ALASKAN WAY VIADUCT

EVALUATION OF GRAY'S RETROFIT PROPOSAL

Prepared for the
Washington State Department of Transportation

By
T.Y. Lin International

Figure 18a

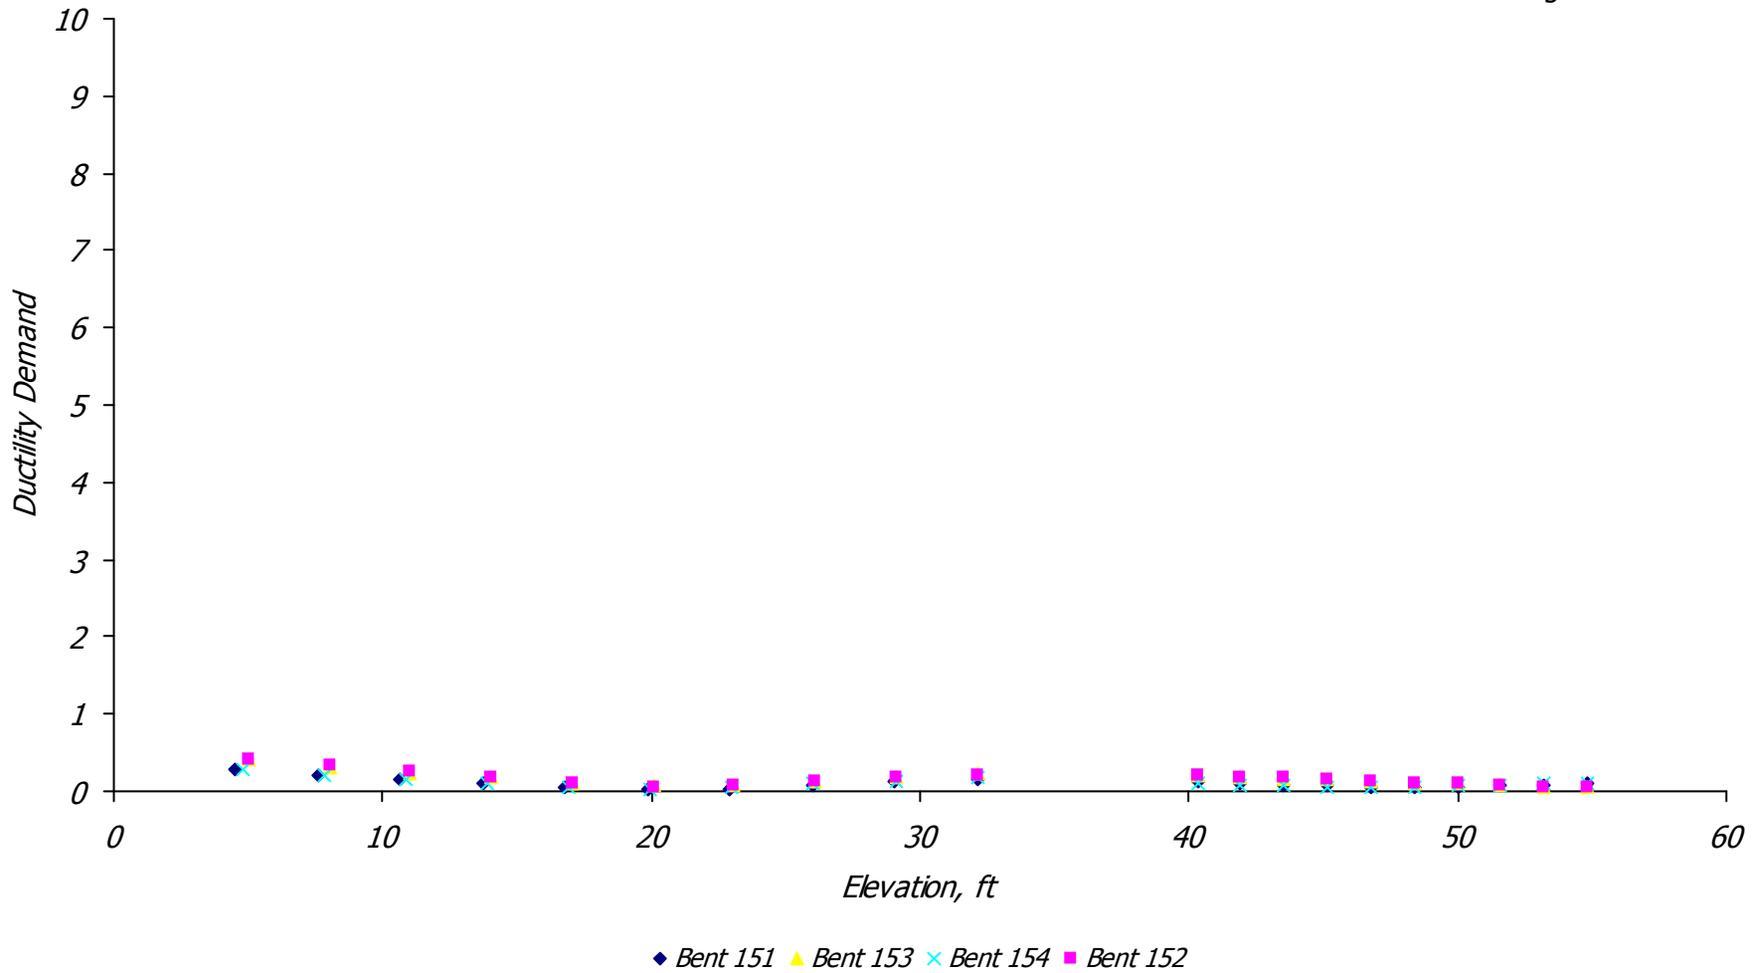
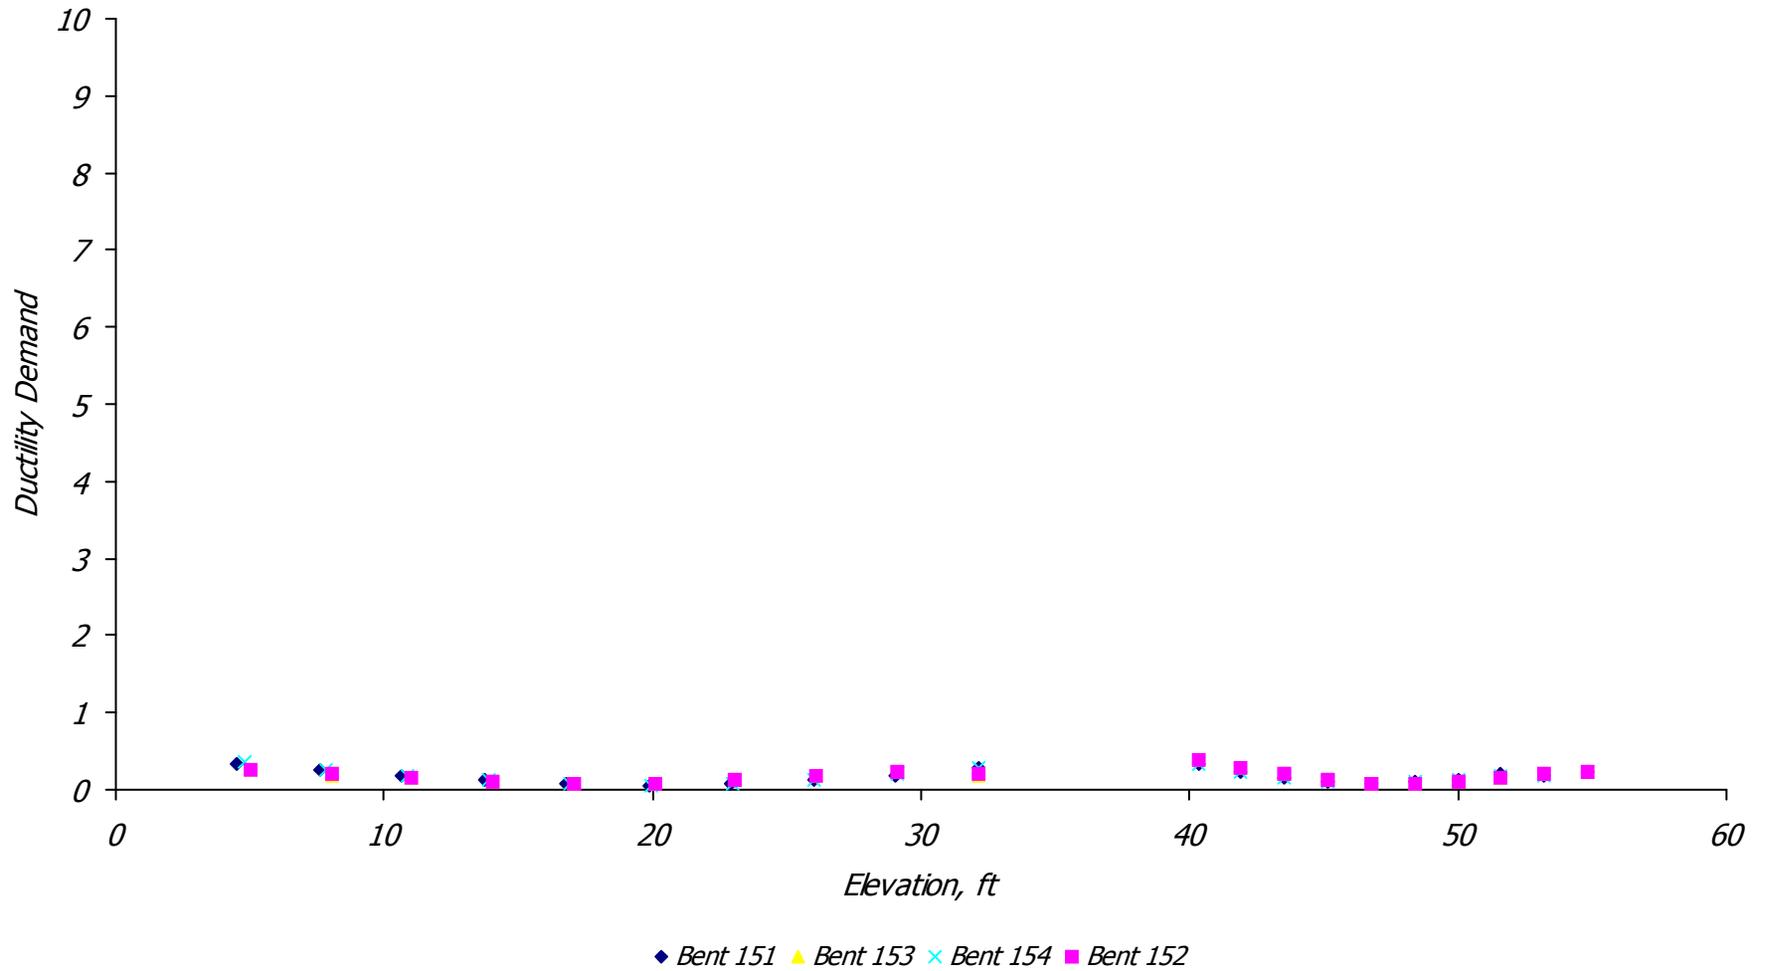
For the expected earthquake, the curvature ductility demands on the columns are summarized in Figure 18. They are all less than unity, so damage would not be expected.

Figure 19a Floorbeam curvature ductility demand, retrofitted structure, rare earthquake, upper level

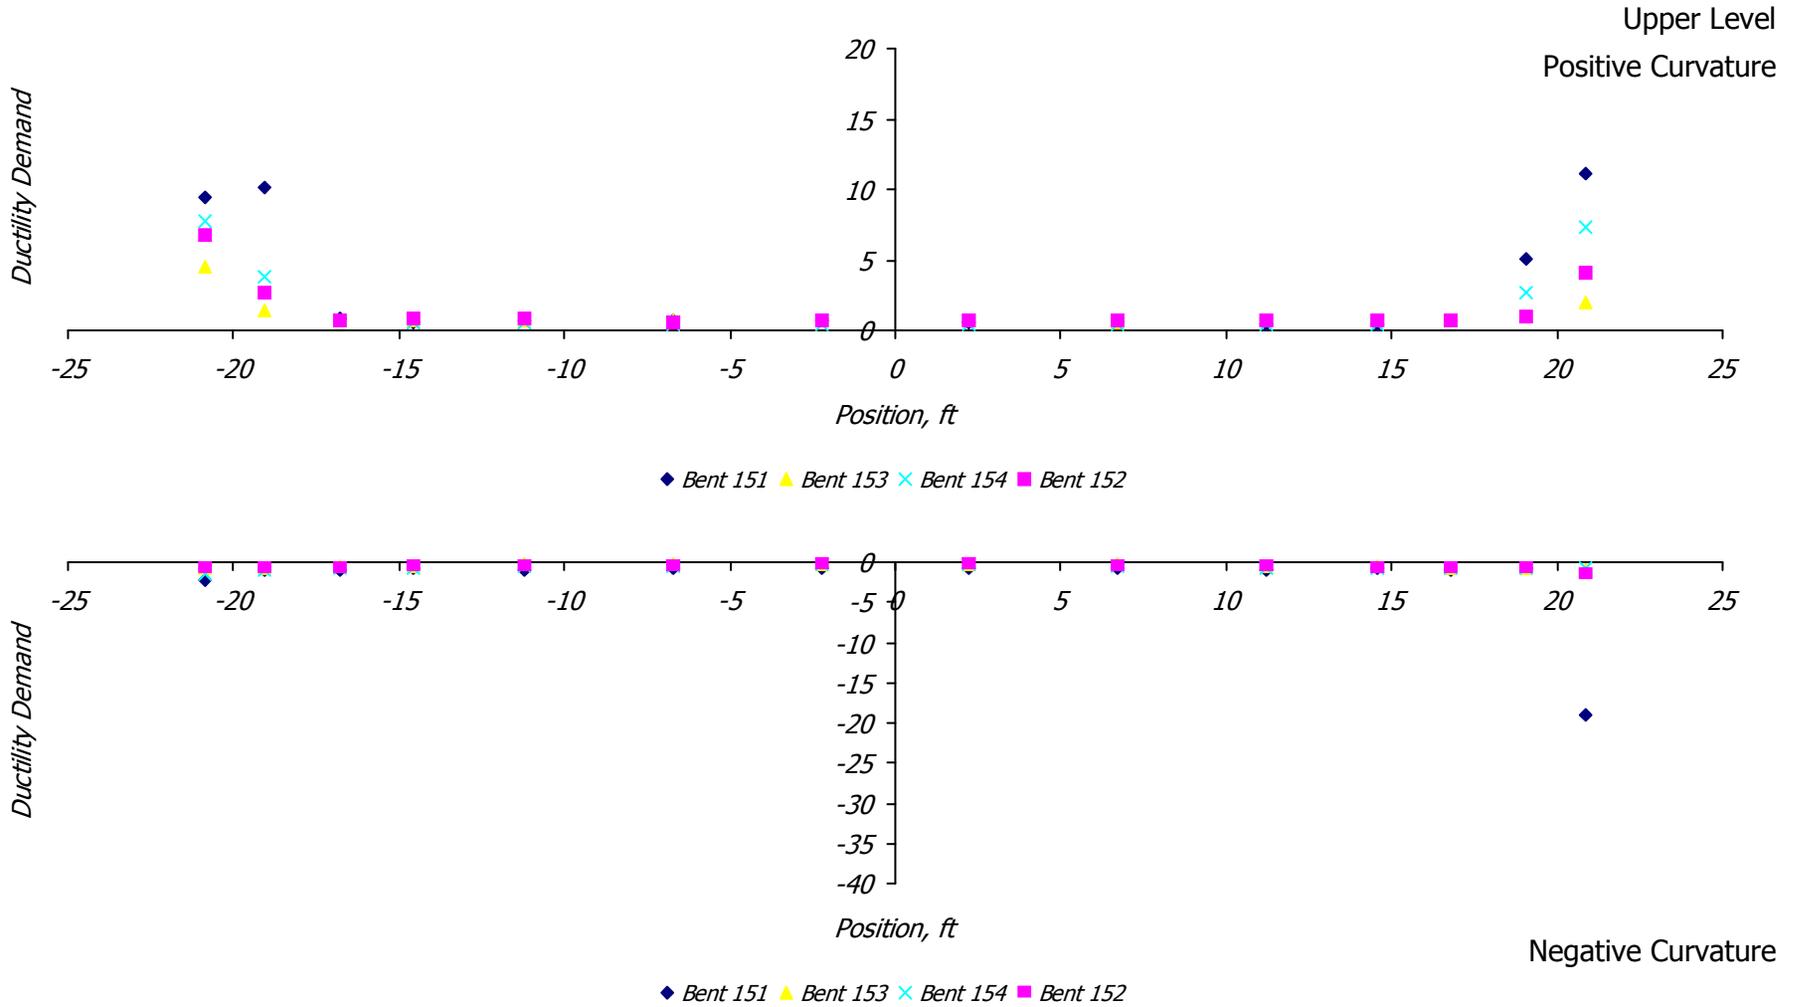
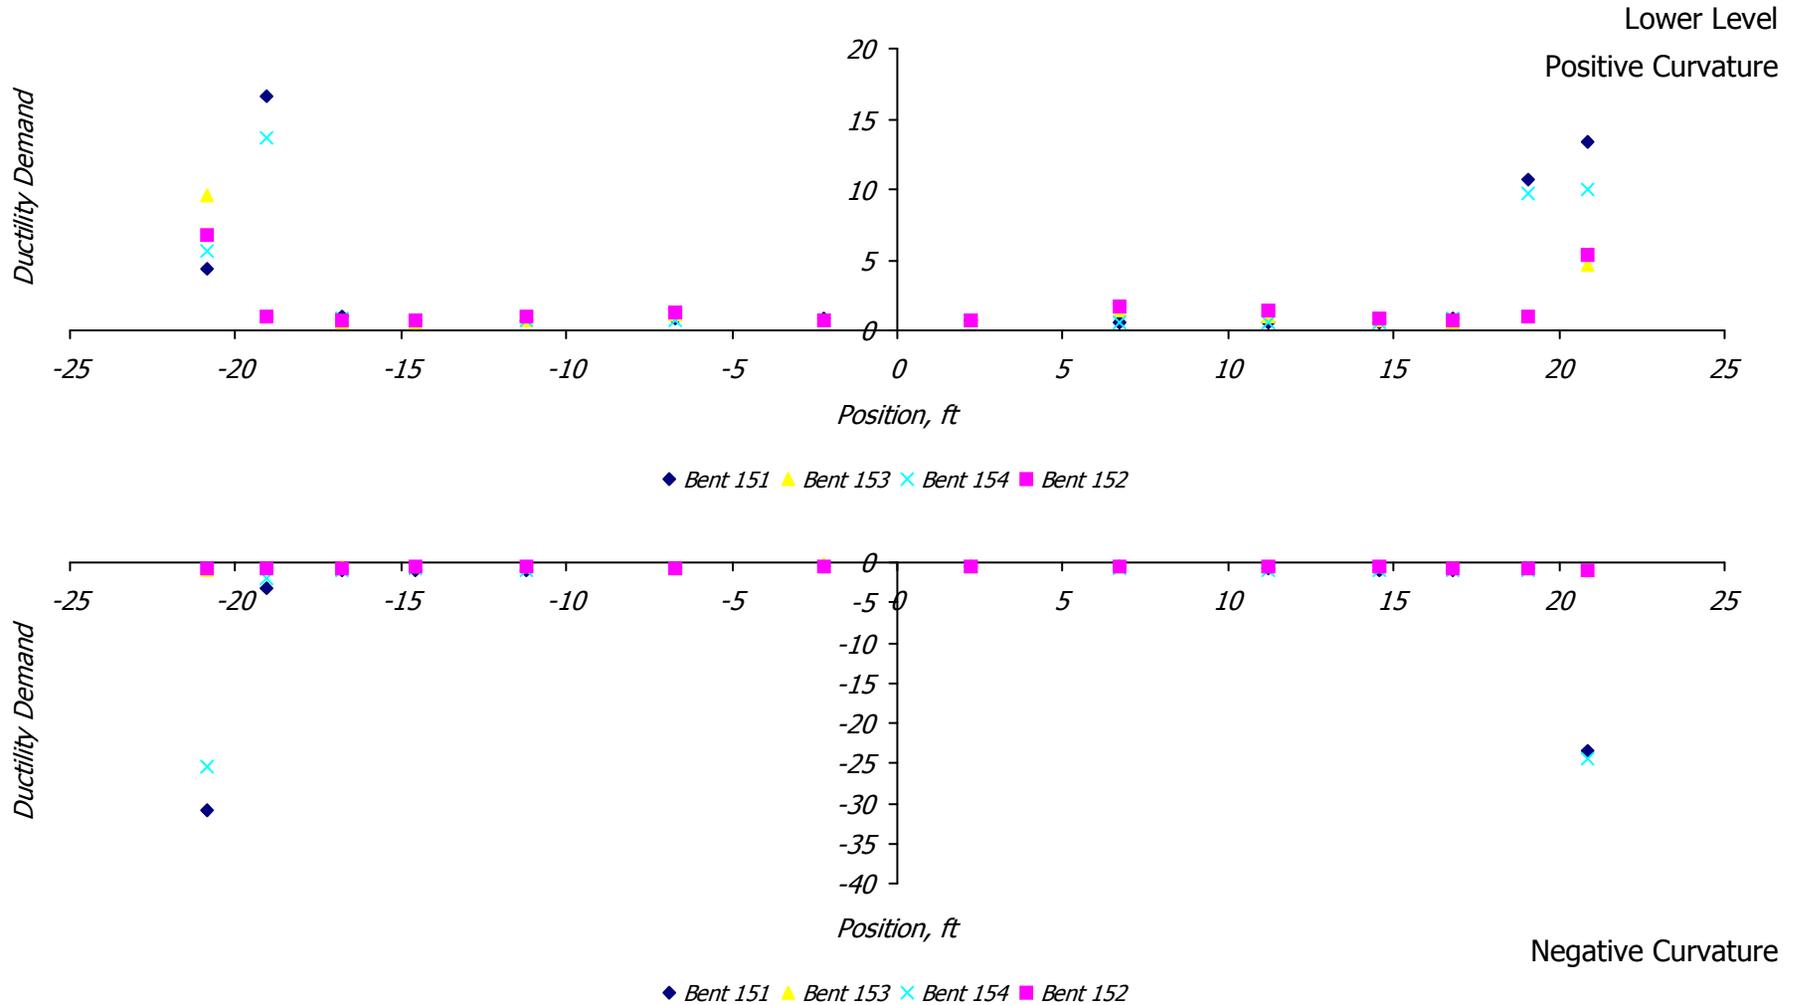
For the rare earthquake, the curvature ductility demands on the floorbeams are summarized in Figure 19. There are separate plots for the upper and lower level floorbeams, and positive (∪) and negative (∩) demands are plotted separately. The plots show that plastic hinges form at the faces of the columns. The largest demands are for positive bending. The floorbeams are reinforced asymmetrically to resist primarily vertical loads and have little bottom reinforcement at the column faces. Evidently, the seismic moments exceed the dead load moments at the faces of the columns so that the total moments are positive. (In the units design by the WSDOT, the primary load path for dead loads is through the edge girders).

Figure 20b Floorbeam curvature versus axial force, retrofitted structure, rare earthquake, lower level

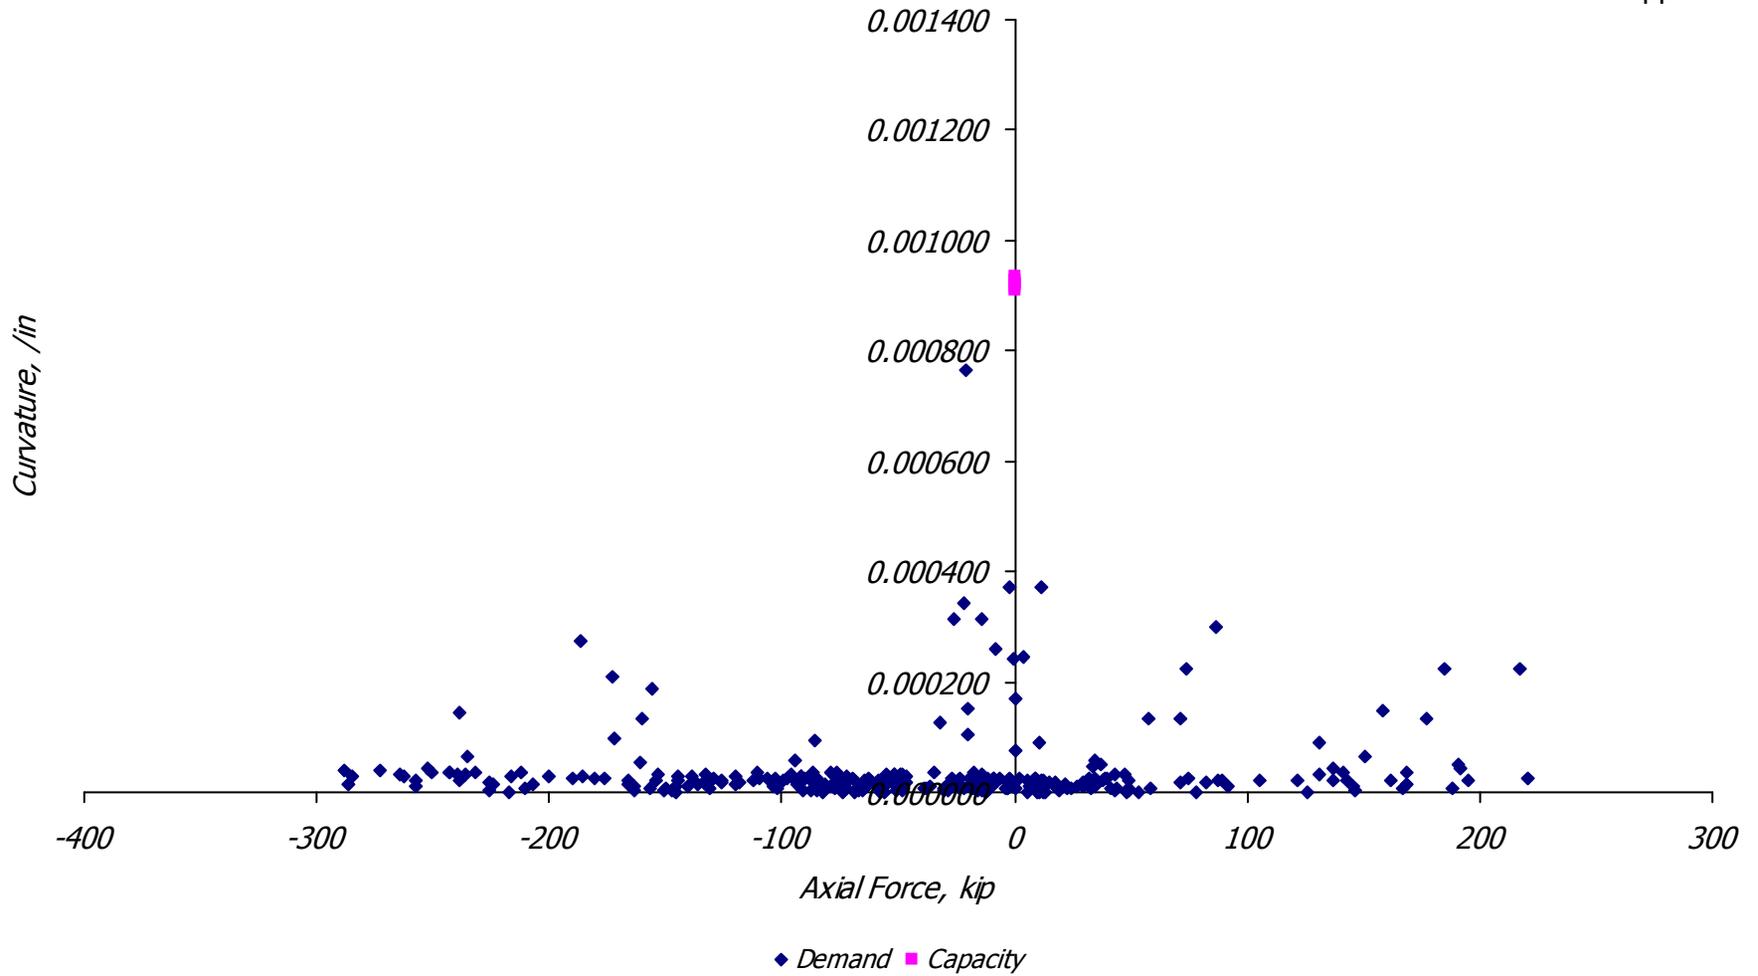
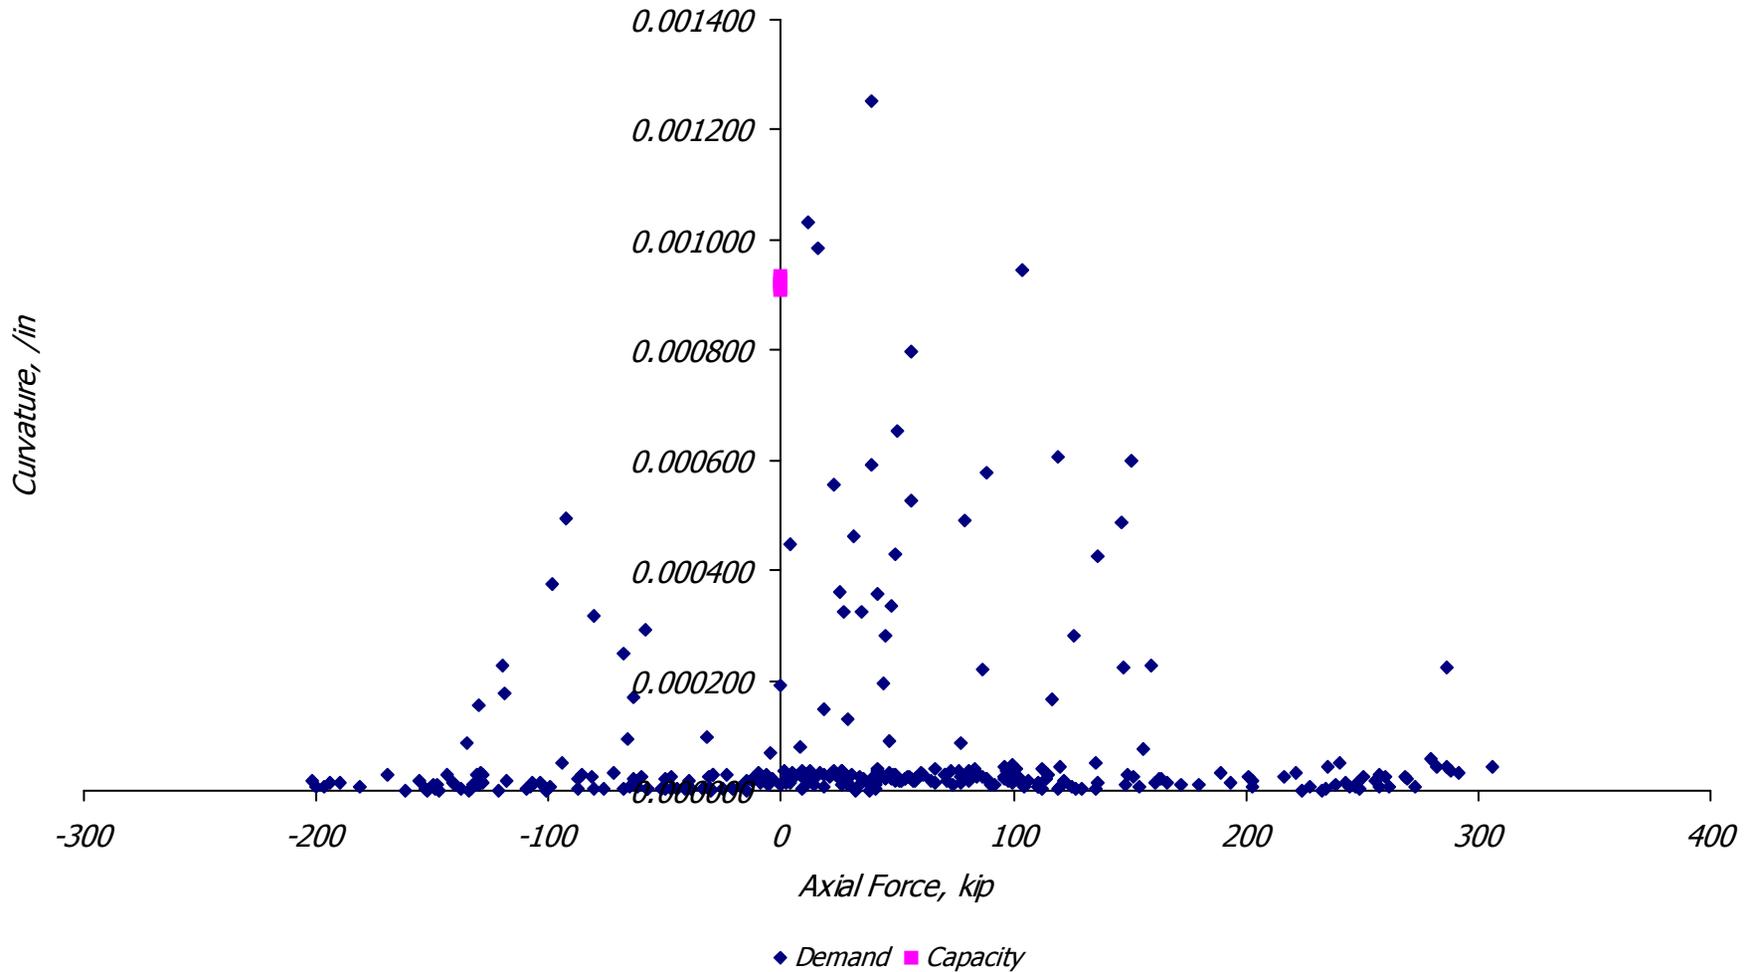
Plots of simultaneous curvature and axial force demands on the floorbeams are shown in Figure 20; there are separate plots for the upper and lower level floorbeams. The capacity curves are represented by clusters of points along the curvature axes (for axial forces of zero). This is because the capacities of the various floorbeams sections are nearly the same, and because the capacity was only calculated for an axial force of zero (because the axial forces in the floorbeams are modest).

Figure 20b indicates that the lower level floorbeams will fail in flexure—in negative bending near one of the columns. This same failure was predicted by the pushover analysis described in Section 4.2.1.1. A demand/capacity ratio of 1.20 was obtained for the middle bents from that analysis. A similar ratio may be inferred from Figure 20b.
